SUBJECT: Abraham Lincoln Capital Airport
Springfield, Illinois
Sangamon County
Illinois Project Number: SPI-4635
SBG Project Number:
Contract No. CA020
Item No. 4A, April 27, 2018 Letting
Addendum A

NOTICE TO PROSPECTIVE BIDDERS

Addition of Power Duct Bank and Handholes to the electrical plans.

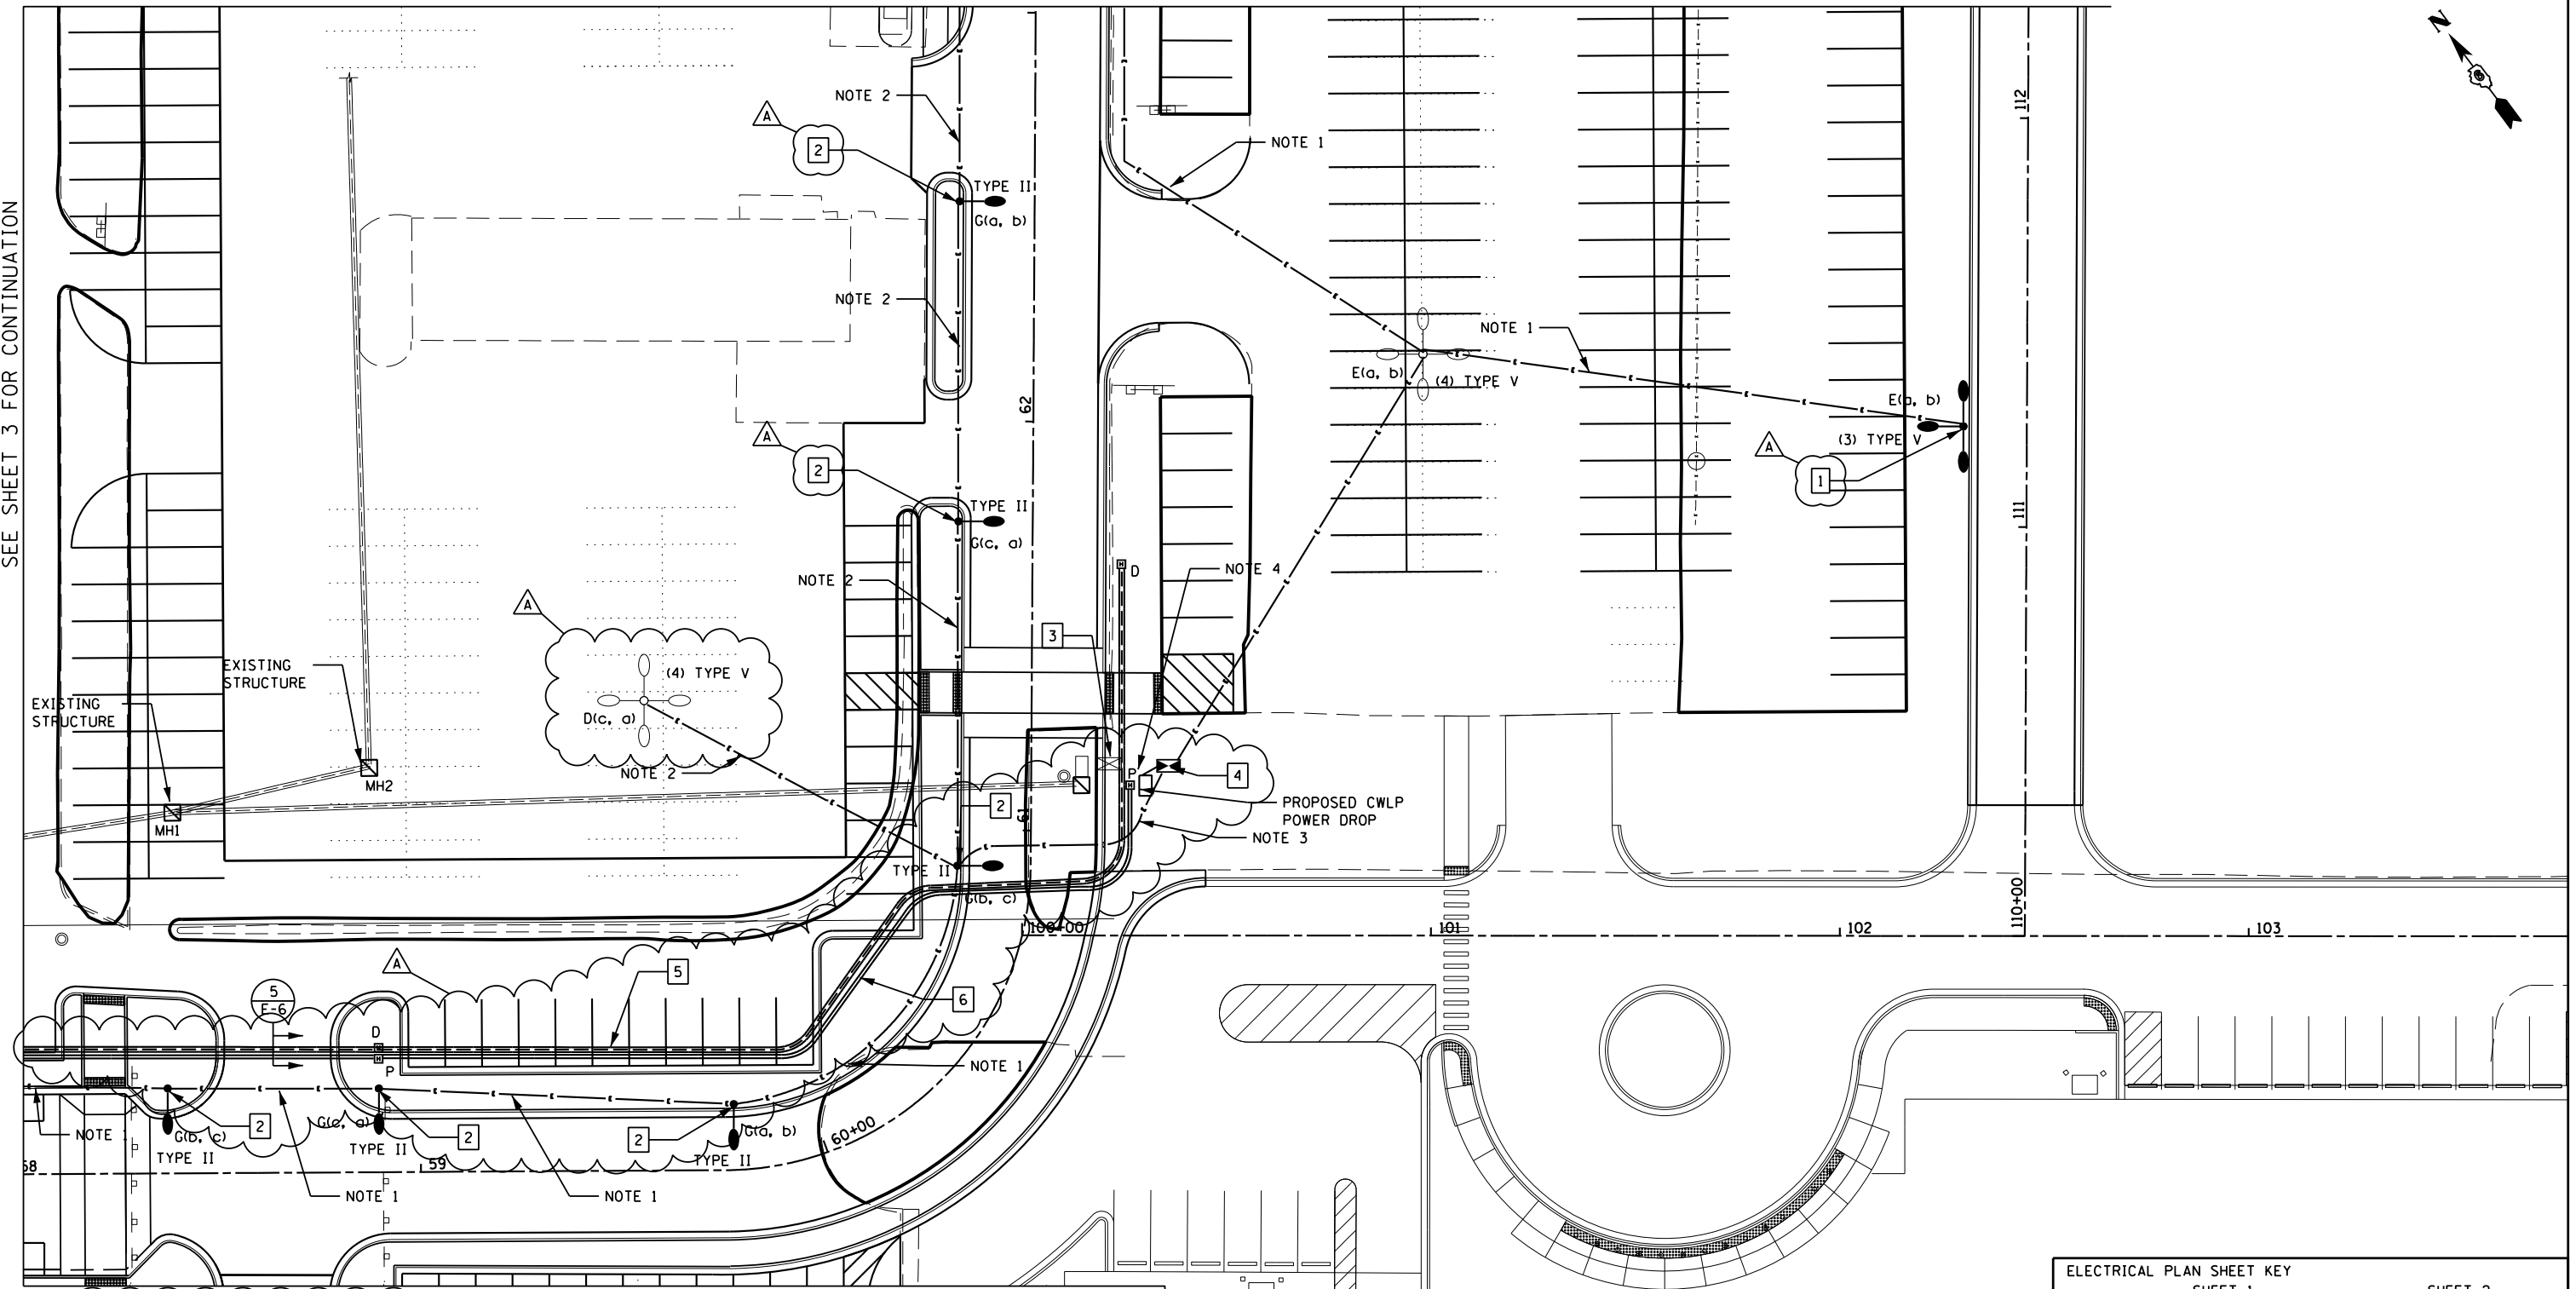
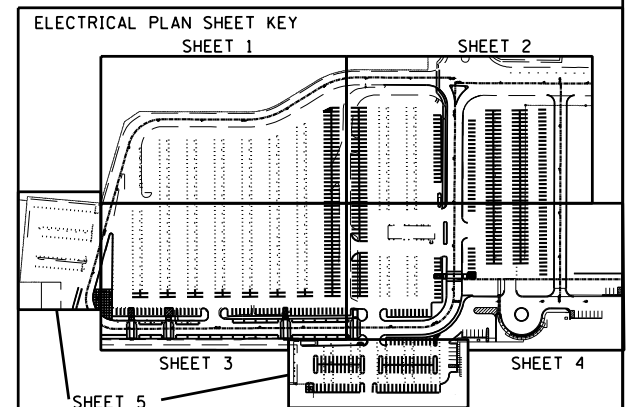
11. Plan Sheet 60-Added proposed power duct bank plan, handholes and notes.
Show fourth luminaire to remain and deleted key note 1. Revised all other key note numbers and revised corresponding callouts on the plan sheet.

- 1 PROVIDE LIGHT POLE AND FOUNDATION PER DETAILS 1 AND 2 ON DRAWING E-7. PROVIDE LED FIXTURE PER GENERAL NOTES ON DRAWING E-0.
- 2 PROVIDE LIGHT POLE AND FOUNDATION PER DETAILS 1 AND 3 ON DRAWING E-7. PROVIDE LED FIXTURE PER GENERAL NOTES ON DRAWING E-0.
- 3 REMOVE EXISTING CONTROLLER AND FOUNDATION AND INSTALL NEW HANDHOLE PER DETAIL ON DRAWING E-7.
- 4 INSTALL NEW FOUNDATION AND CONTROLLER PER DETAIL ON DRAWING E-6 AND ROUTE NEW CONDUIT AND WIRING FROM NEW HANDHOLE.
- 5 PROPOSED DATA DUCTBANK 6-2" PVC CONDUIT ENCASED IN CONCRETE
- 6 PROPOSED POWER DUCTBANK 4-4" PVC CONDUIT ENCASED IN CONCRETE

TOTAL SHEETS	SHEET NO.
75	61
IL. PROJ. SPI-4635	DRAWING E-5

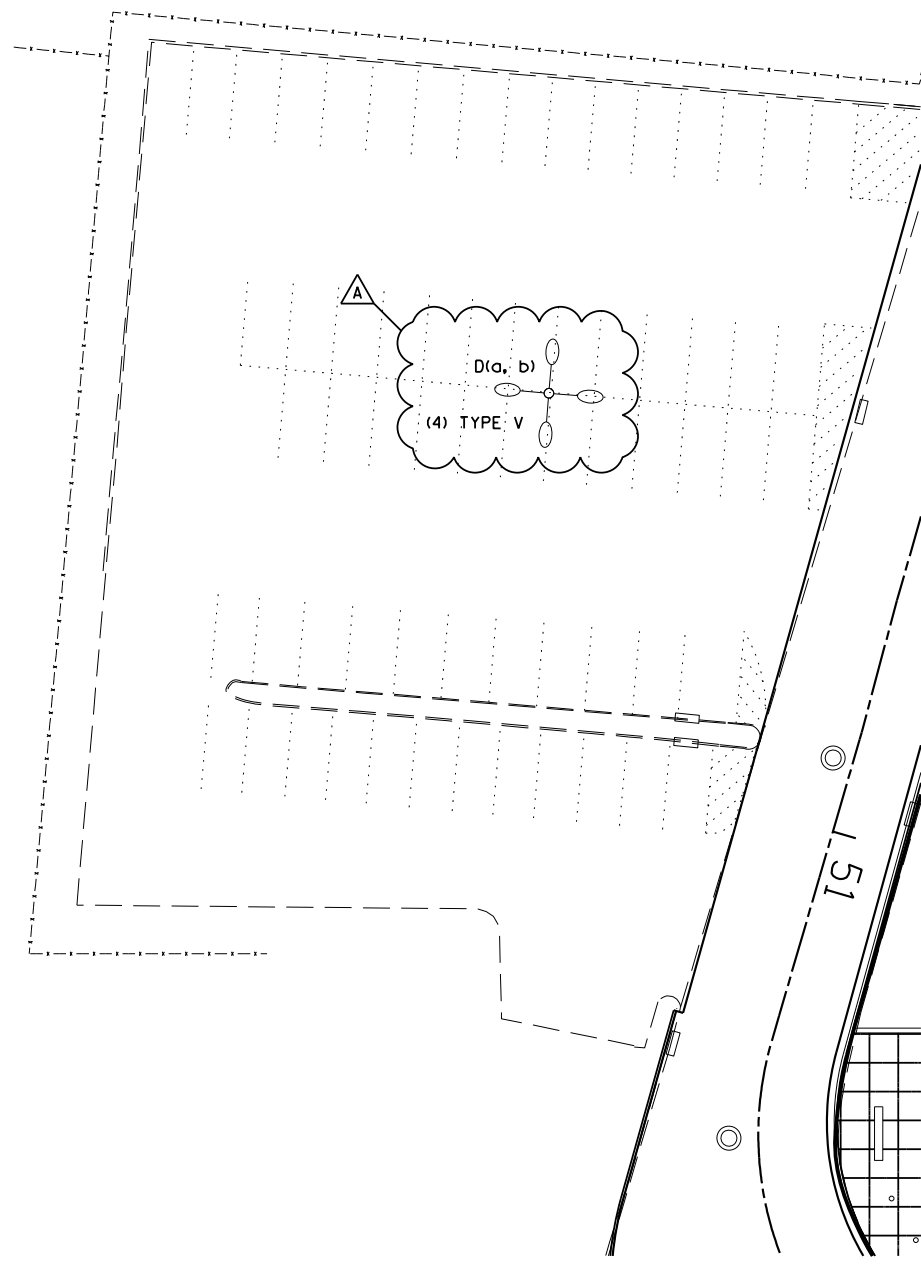
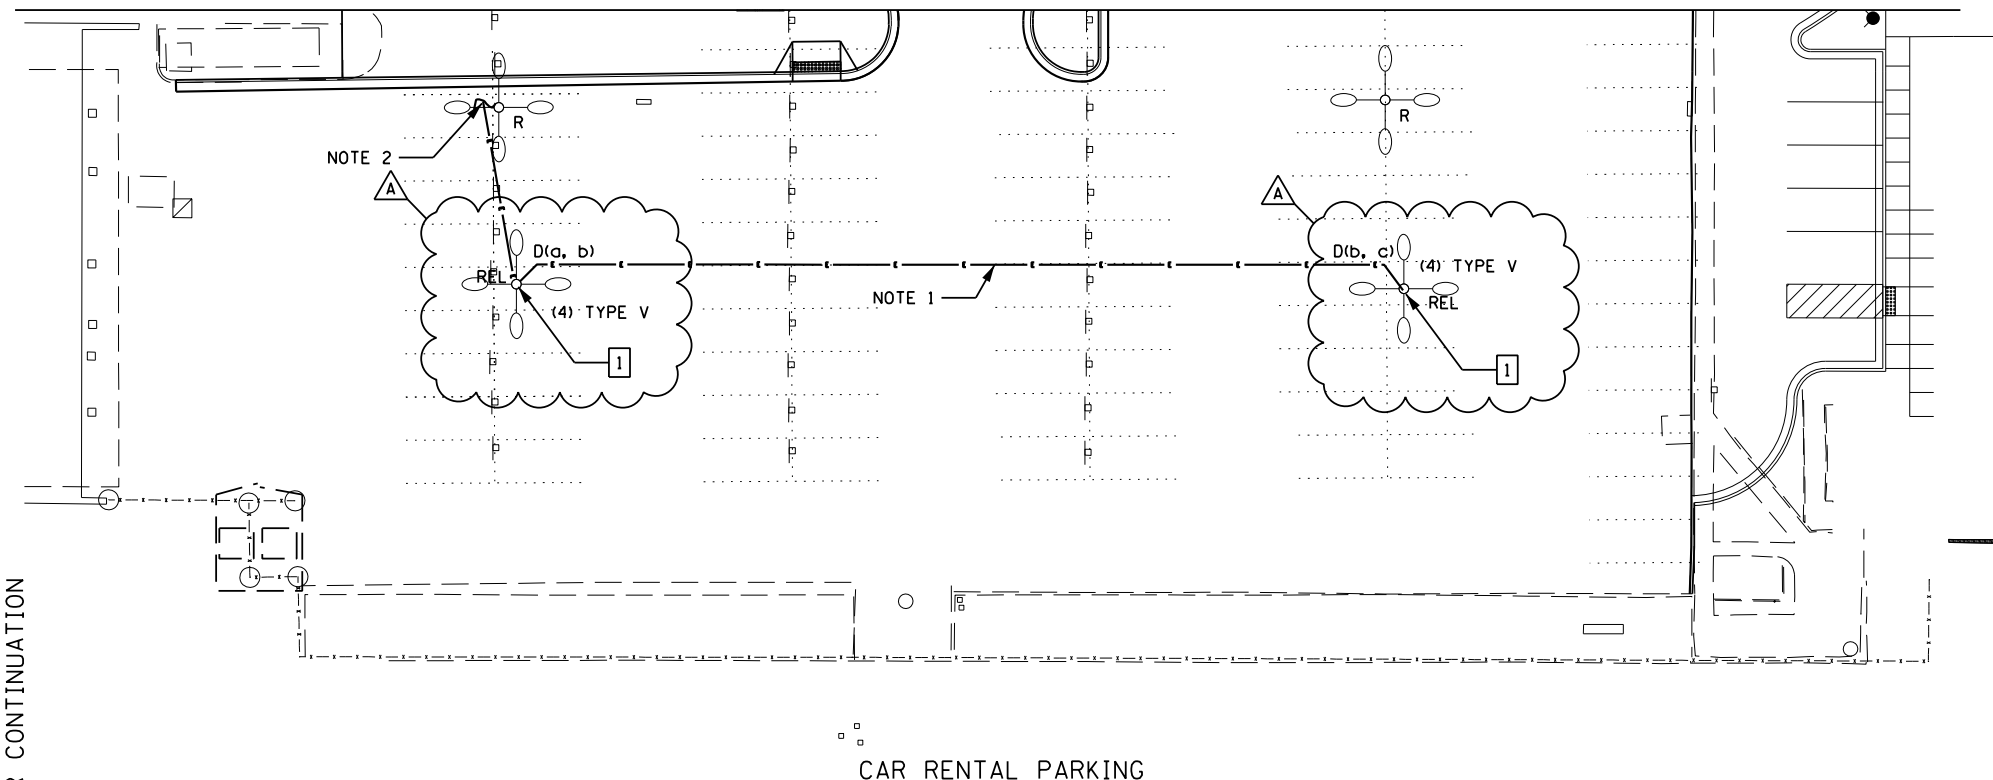
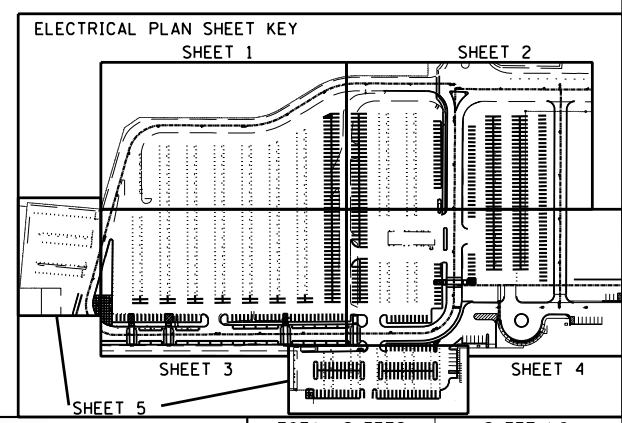
12. Plan Sheet 61- Revised all other key note numbers and revised corresponding callouts on the plan sheet.
13. Plan Sheet 62-Added power duct bank to Detail 5.

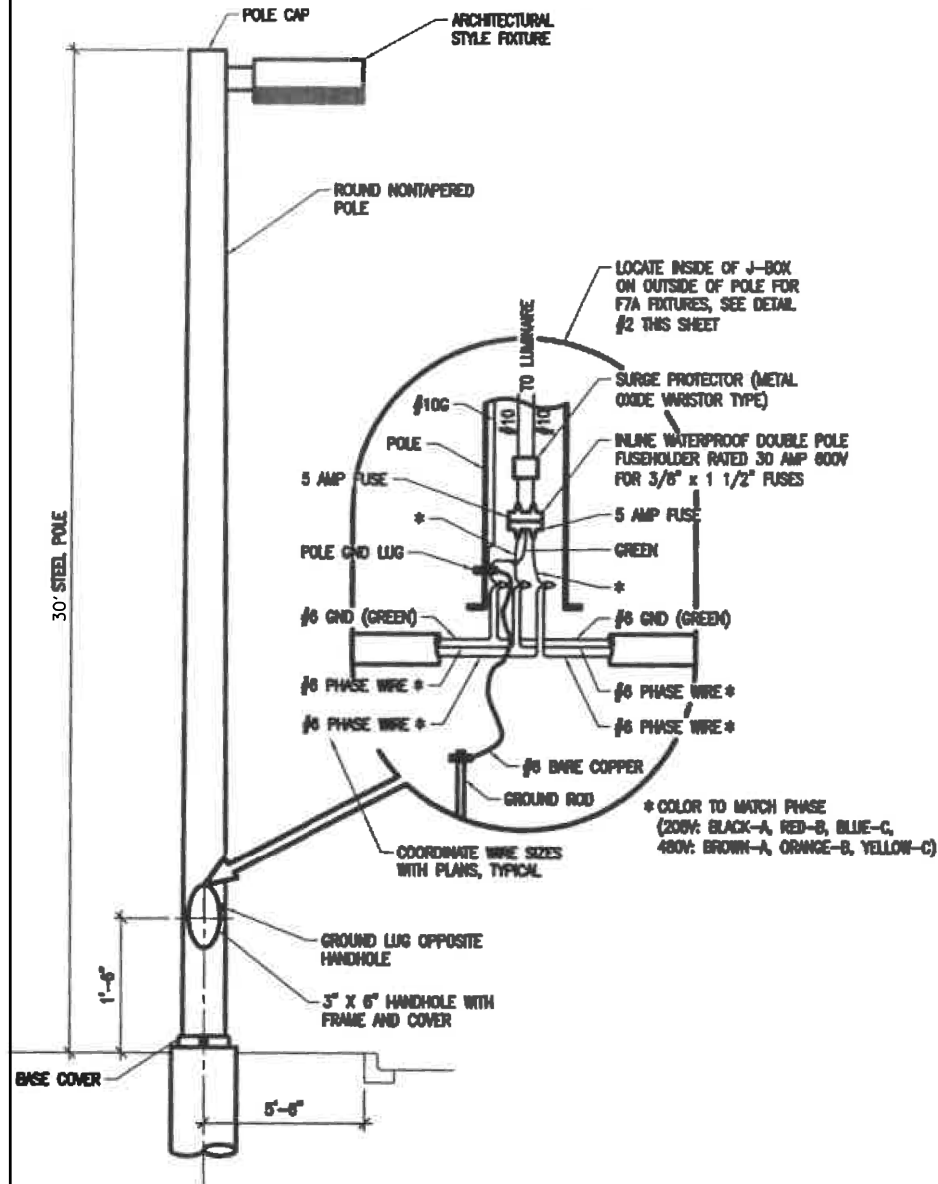
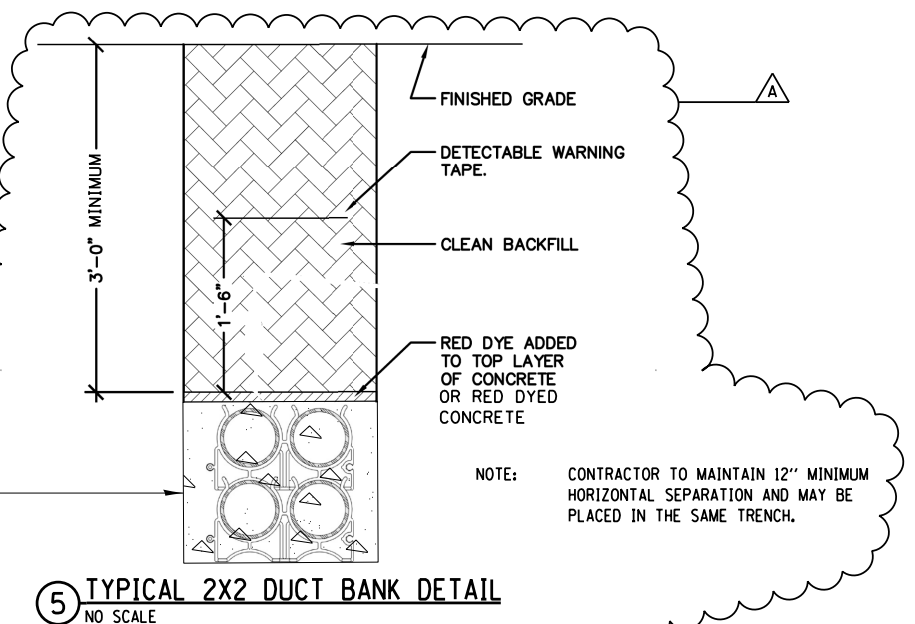
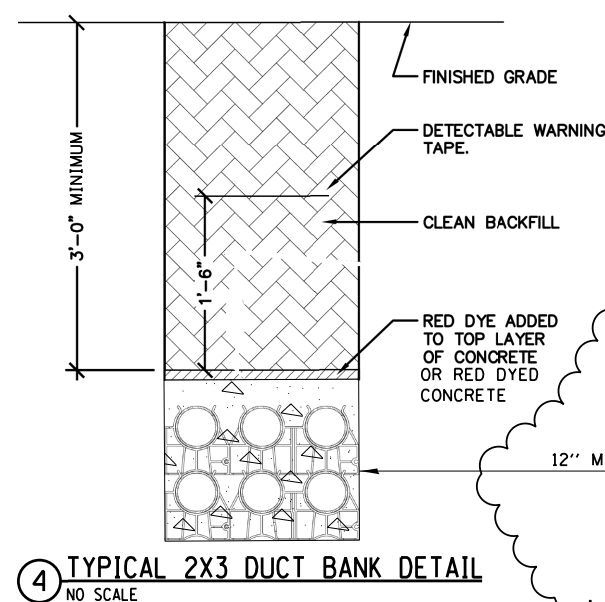
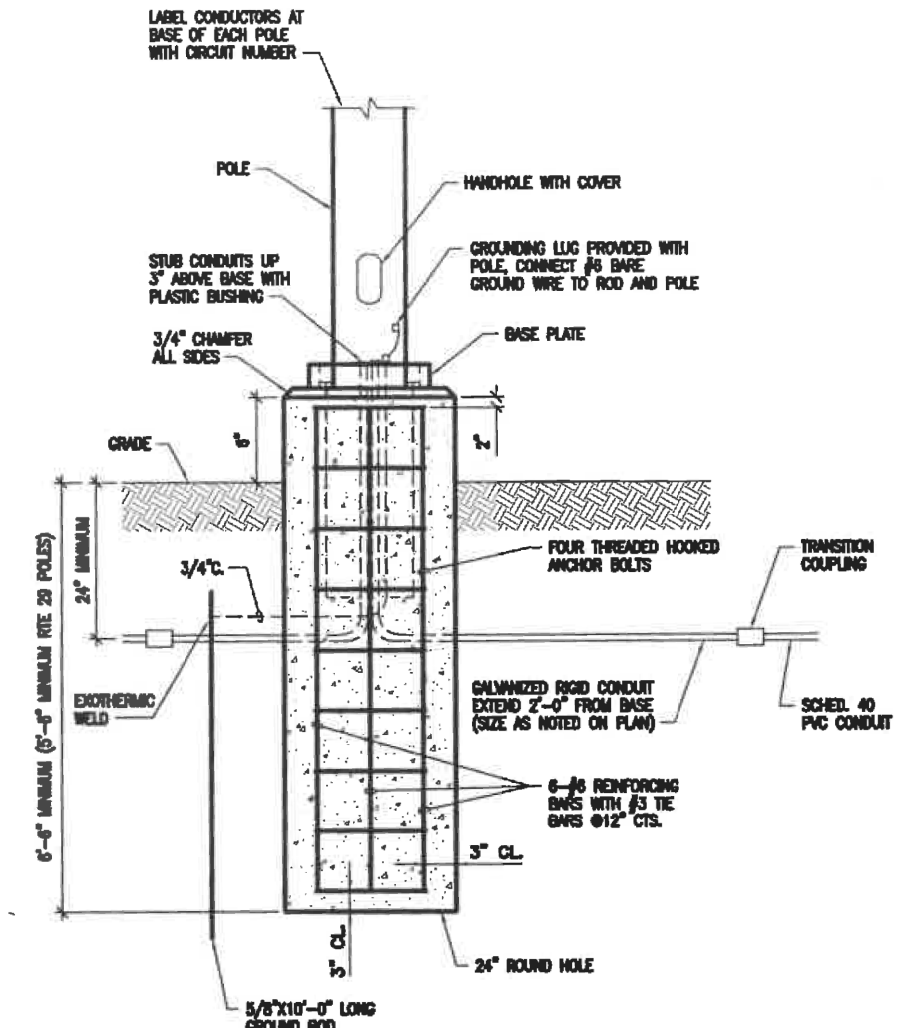
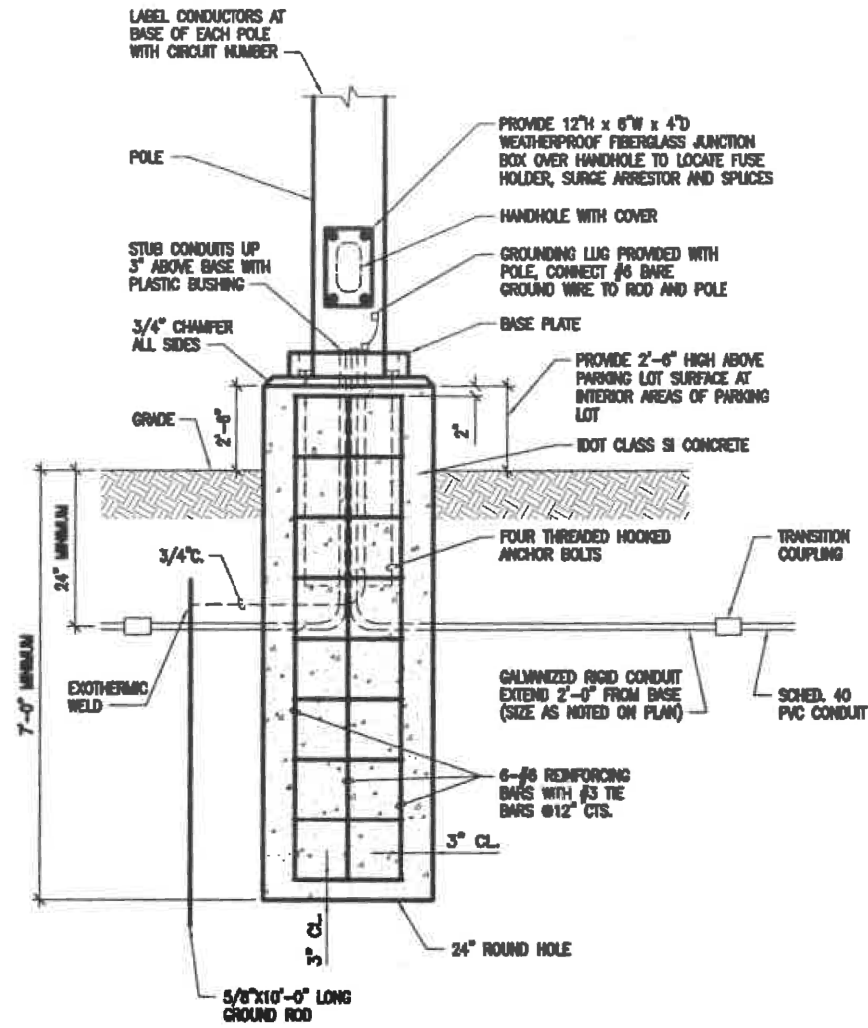
14. Plan Sheet 63-Added note at bottom of sheet. Modified Detail 4 to show 2x2 power duct bank.
